M۱	/P Varia	ance R	equest	Form	Varia	ance Request No.:	D-5		
13 1/0	ıntain			Date An	nroval R	aguastad	by Contractor:	4/25/20	18	
Mou	untain Vallov			spector to LEI:	4/20/20	10				
	PIPELINE uc			Date Sur		•	ved by FERC:			
			FE	RC Approv			100 27 1 2110.			
							Variance			
Requested By:	Rich Anderson			Sp	read:	D	Type:	WS		
Request Prepared By *:	Megan Nevlon					Varia	ance Sequence Number:	005		
Request Prepared By *: Megan Neylon * The FERC compliance monitor should be alerted and given a copy of the draft variance for review prior to submittal										
Location (Use either Station or Milepost)										
Station:	N/A	To:	N/A	Milep	ost:	N/A	To:	N/A		
		Ancillary	7 977 1							
Alignment	Sheet Number:	Sites			_	Tract No.:	Prec	ision lease		
Current Land Use/ Vege	etative Cover	Developed				Agency diction:		N/A		
Nearby Features (Water body		and, Noxious	Weed Area	, Residence				☐ Yes [☑ No	
(distance), Cultural Resource		•			In or w/i	n 50 feet o	f a wetland:

Mountain Valley Pipeline Project Variance D-5 April 10, 2018

Mountain Valley Pipeline Project Variance D-5 April 17, 2018

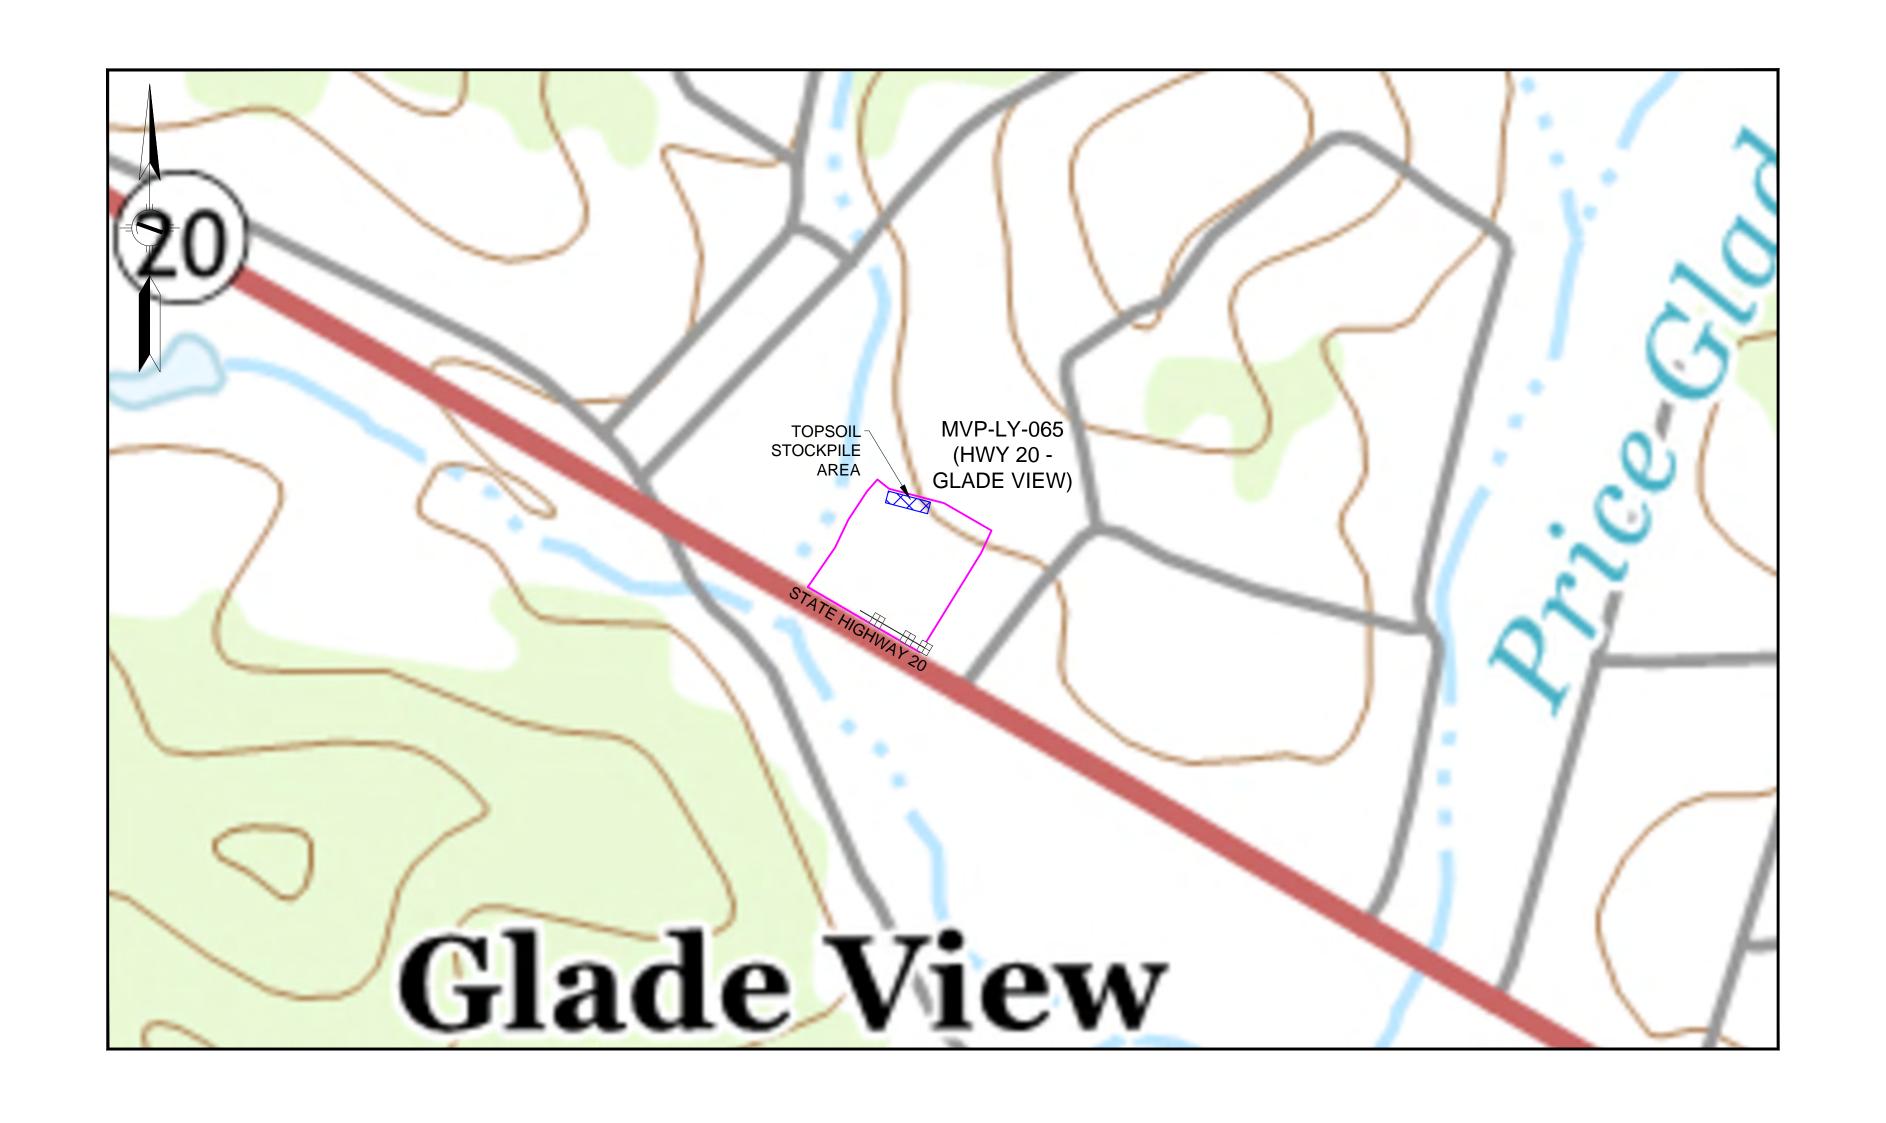
State Route 20. The area	·					•				
	1045-15 (1 0 °)		4. A4:		Tl '					
List Attachments:	Attachment 1-Aligi Endangered Spec									
	Report; Attachmer	nt 4- Cultura	l and Histor	ic Resource	es Report	(CUI/PRIV				
	DO NOT RELEAS									
						·				
Variance Justification:							<u> </u>			
Laydown yard necessary for BMPs will be installed to mir								d Project plans	S,	
Divir 5 will be installed to IIIII	iiiiiizo iiripacio io a	y Environin	normany oer	onive Areas	, with iir i/ dl	Jaming the a	arou.

Waterbodies and Wetlands Report Attachment 3

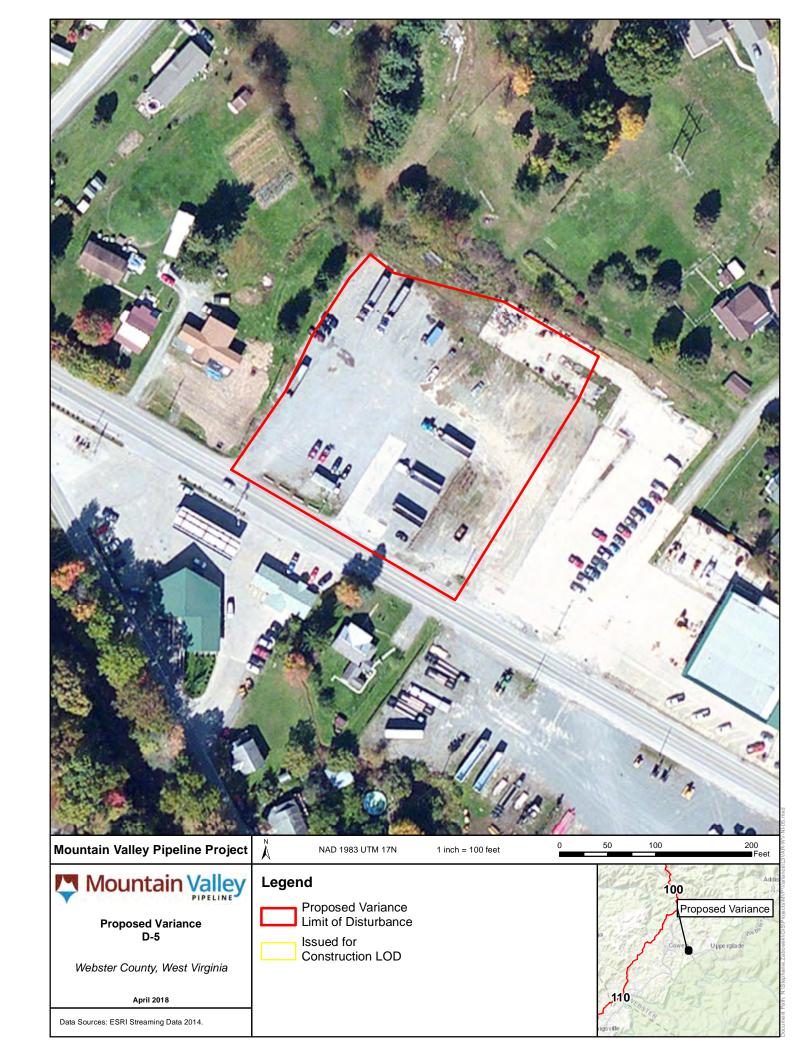
During field surveys, Tetra Tech did not identify any wetlands or streams in the survey area as shown on the attached figure.
